Addendum No. 1

Re: Part B - James M. Seals, JR. Park – Athletic Restroom/ Concession and Field Improvements
504 Texas Street, Mobile, AL 36603
Project No. PR-041-20
Part C - Hackmeyer Park – Improvements Phase 2
3810 Conway Drive South, Mobile, AL 36608
Project No. PR-034-21

Date: November 14, 2022

3 CITY OF MOBILE - CONSTRUCTION JOB SITE SIGN

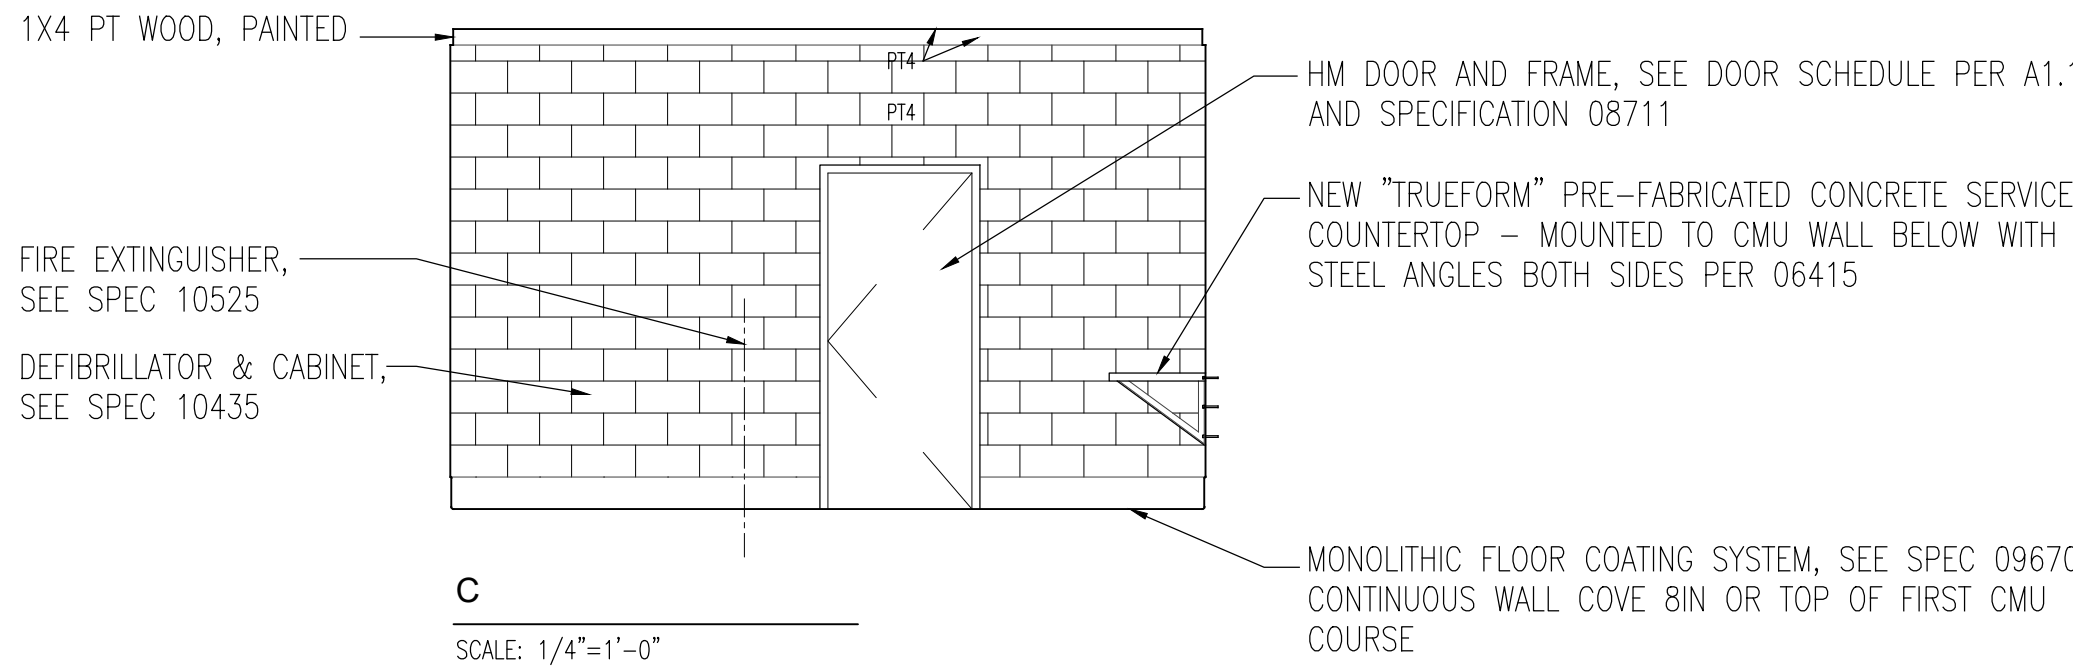
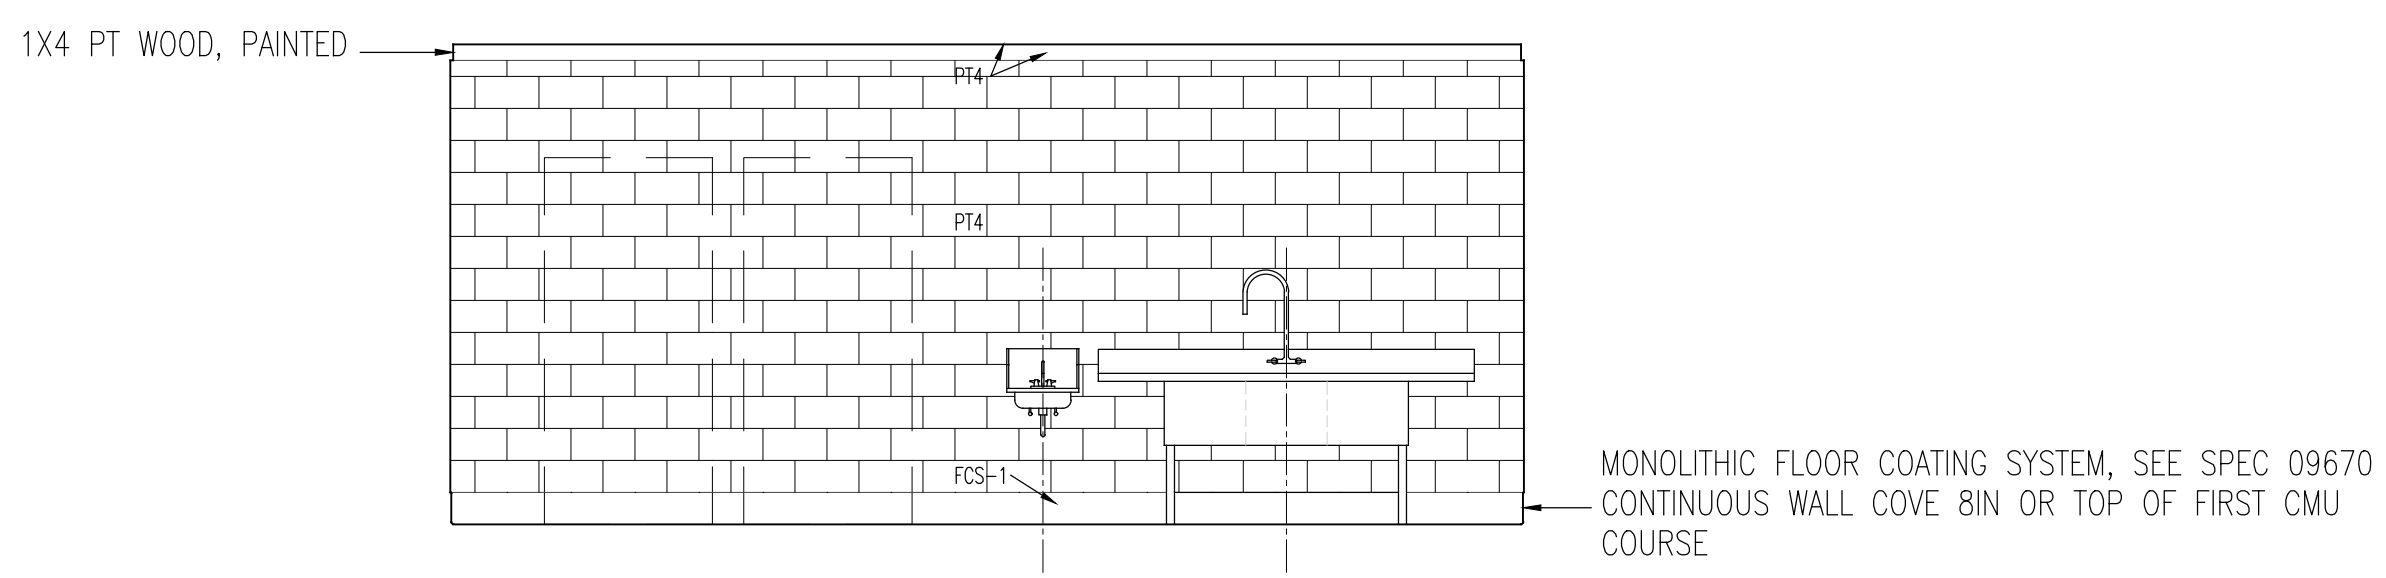
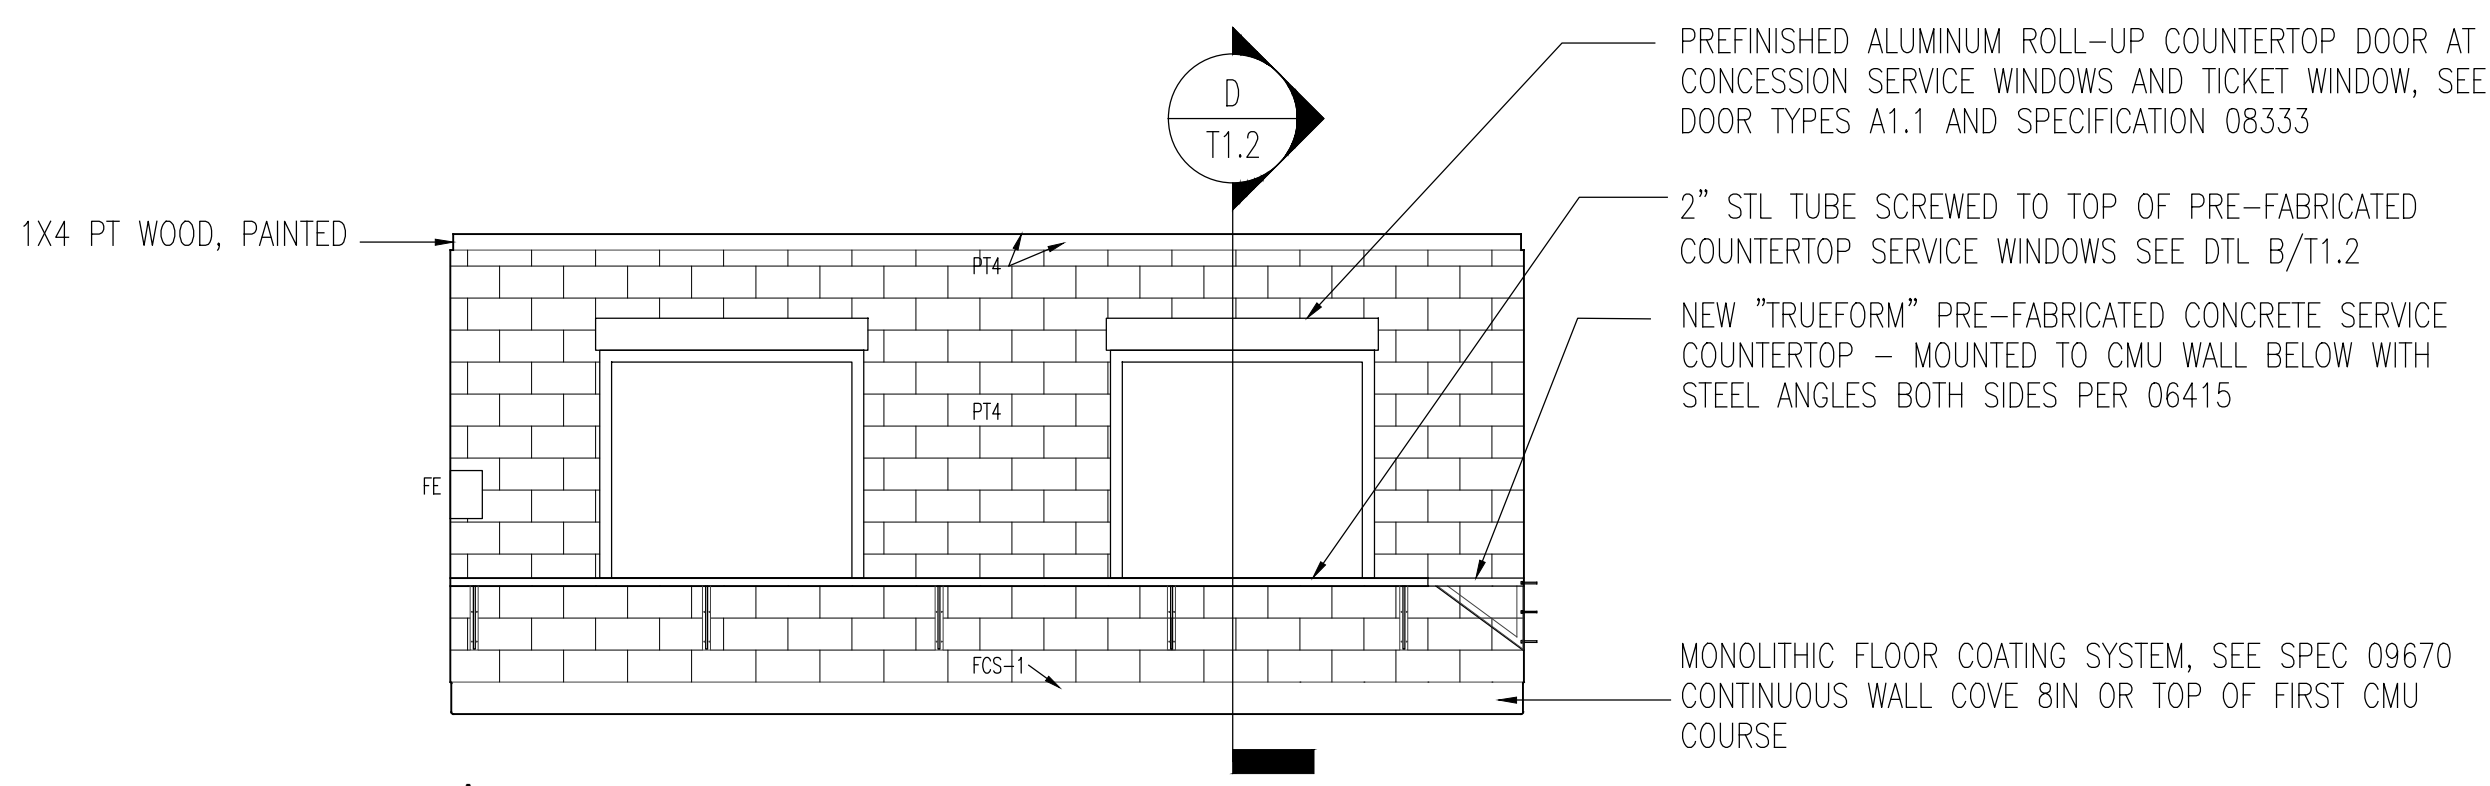
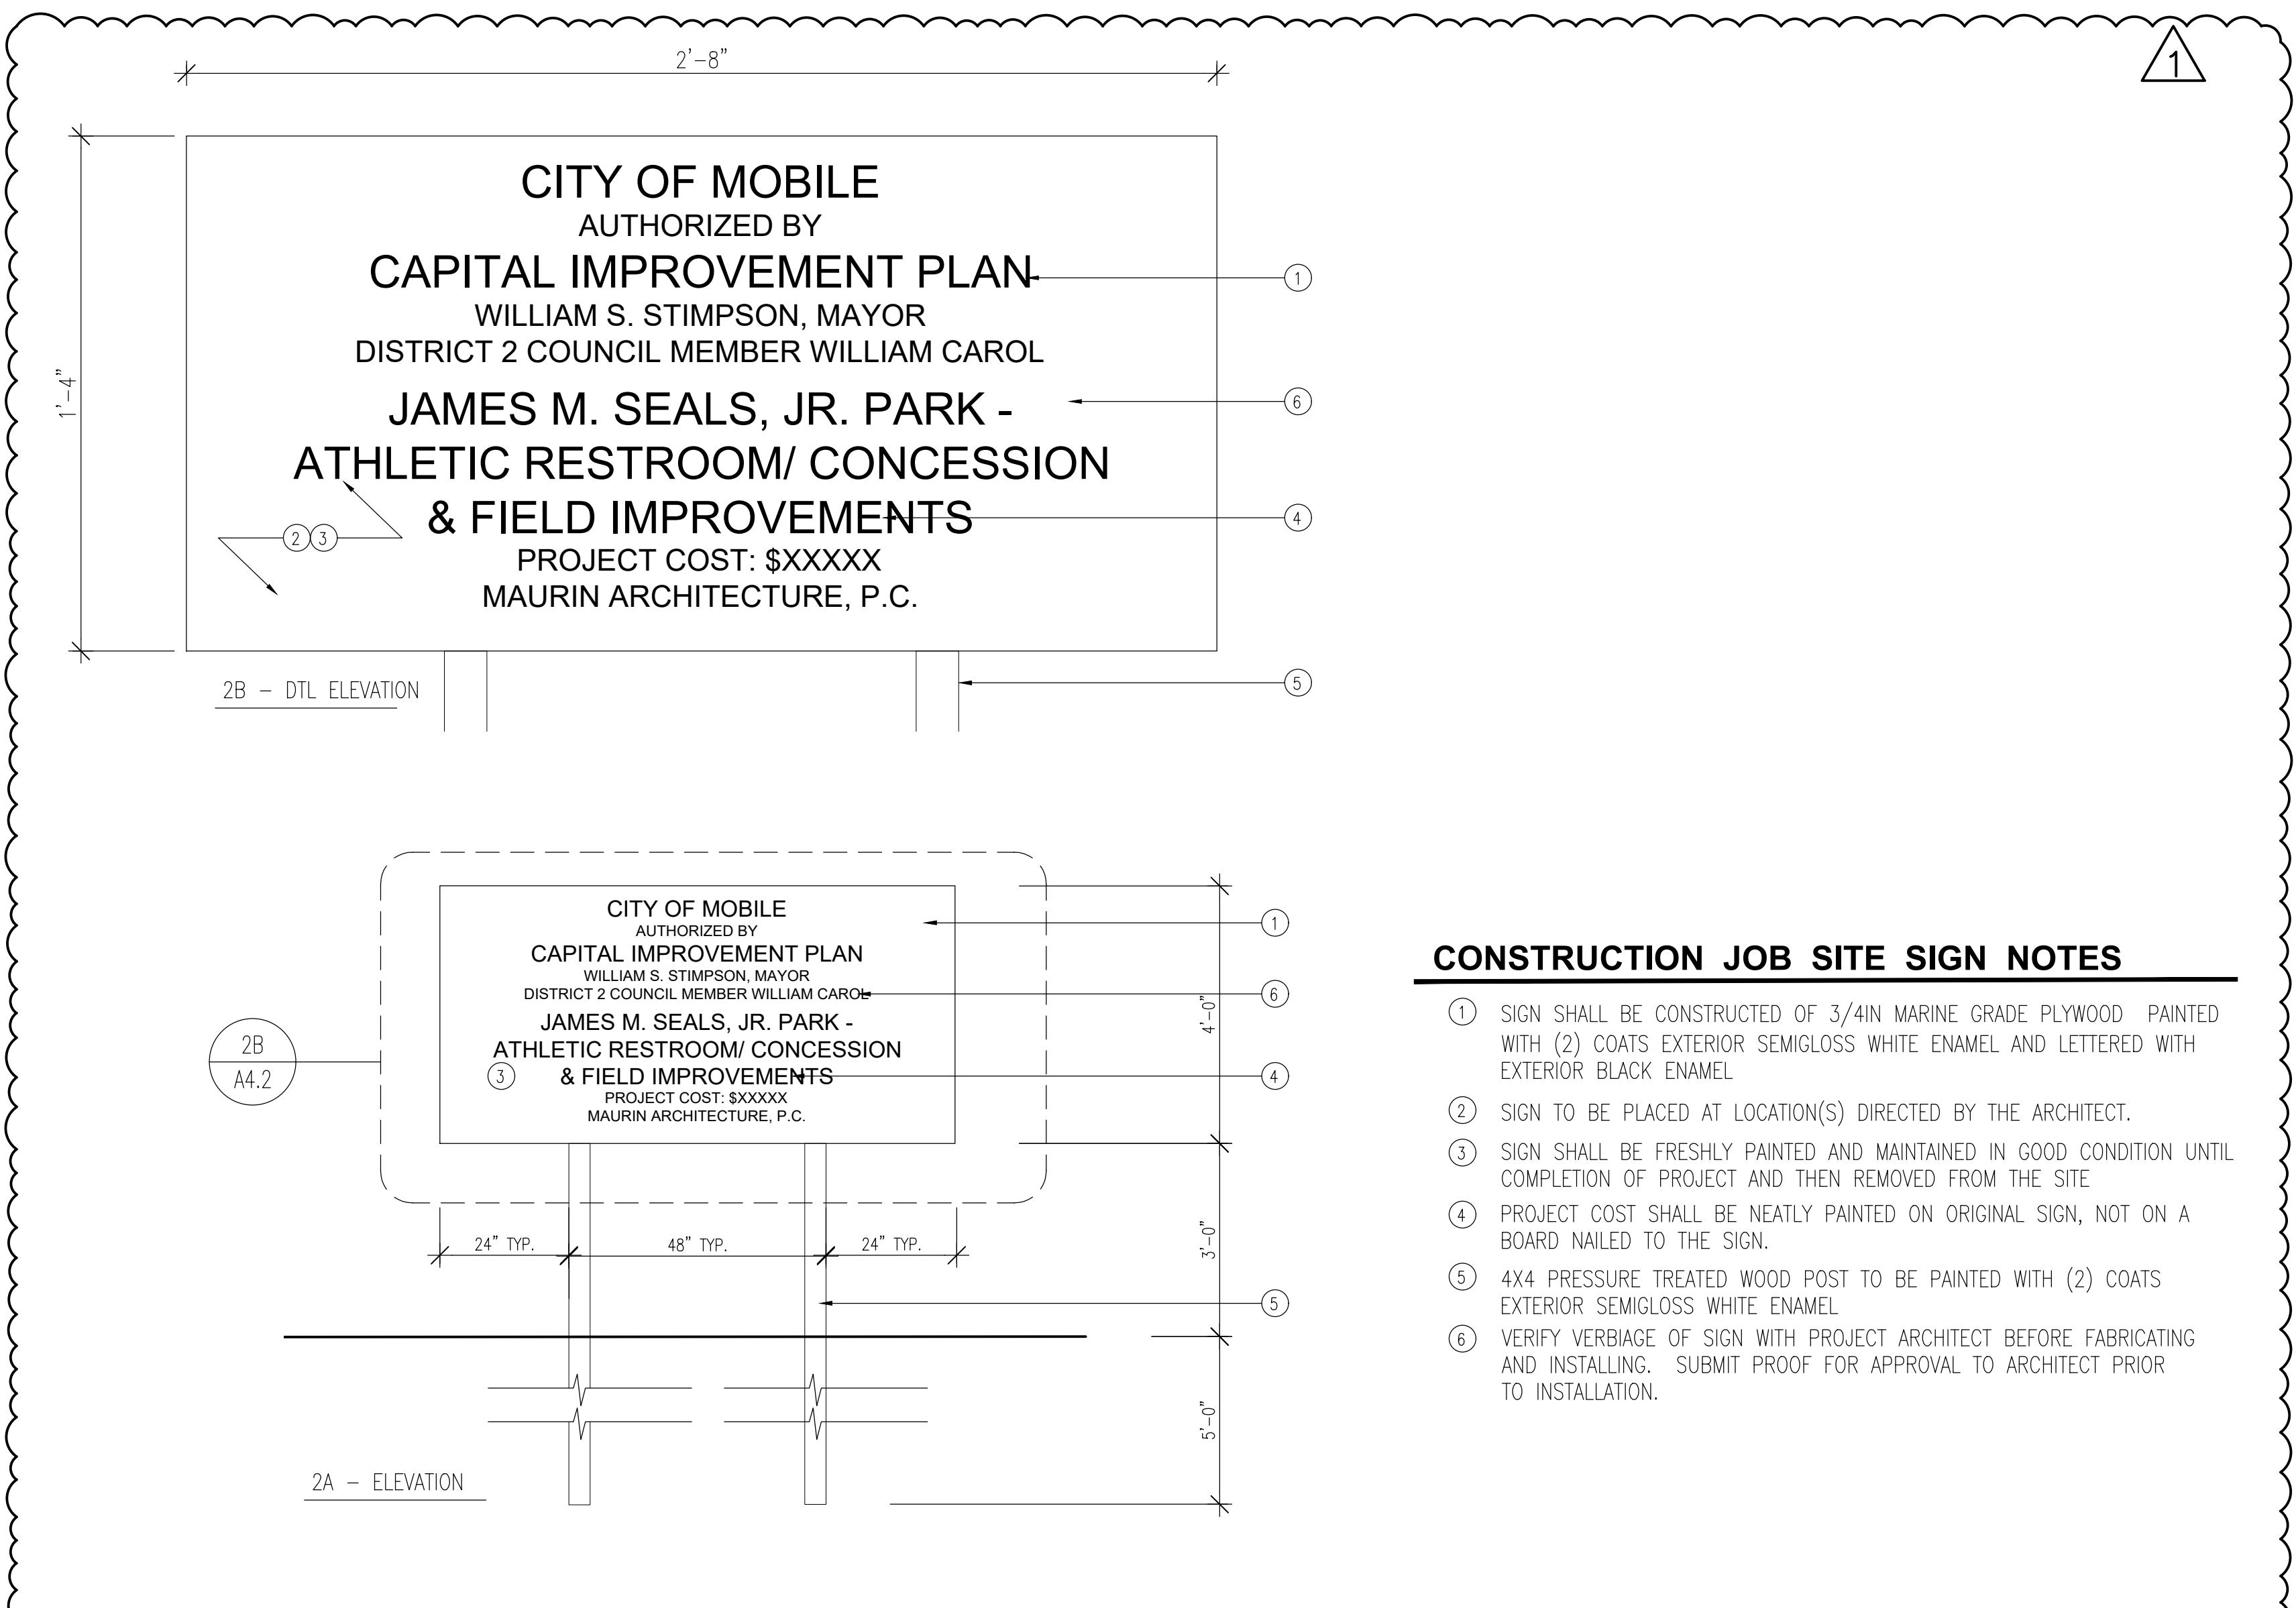
Item 20: Sheet A4.2 Interior Elevations – Concession & Family Restroom

Replace this sheet dated 11.02.22 with the attached revised sheet of same title A4.2, dated November 07, 2022 and labeled Revision 01 (Addendum No. 1). Substantial changes include the following:

- Add Project Job Site Sign details.
